TITLE: 3PC. NYLON INSULATED 22-18 BARREL, RING TERMINALS

CUSTOMER DRAWING

DRAWING NUMBER: A41543

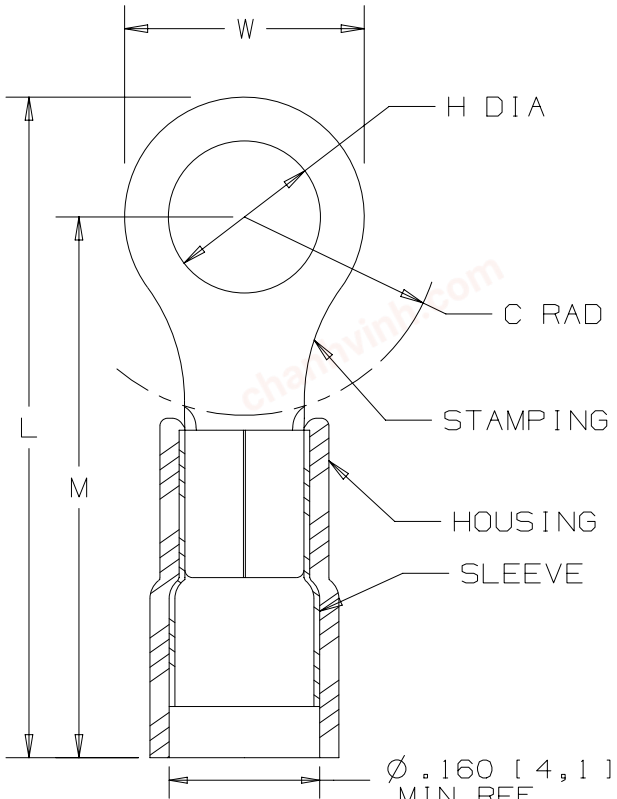
REV	DATE	BY	CHK	APR	DESCRIPTION	ECN
15A	06-15-26	ANVM	ANVM	JSUN	- REMOVED MILITARY CLASS 2. - REMOVED OBSOLETE PART NUMBERS: PN18-12R - UPDATED TITTLE BLOCK AND NOTES TO LATEST STANDARDS. - UPDATED L TOLERANCE FROM ".03" TO ".08" - UPDATED M TOLERANCE FROM ".03" TO ".06" - ADDED WIRE ENTRY Ø REF DIM. - UPDATED UL APPROVED TOOLS.	026842/00
14A	05/01/14	JHNU	JHNU	TMR	REVISED L DIMENSION: PN18-14R: 1.05 WAS 1.09, PN18-56R: 1.04 WAS 1.09, PN18-38R: 1.14 WAS 1.17, PN18-12R: 1.32 WAS 1.35	N41543BA - A41543
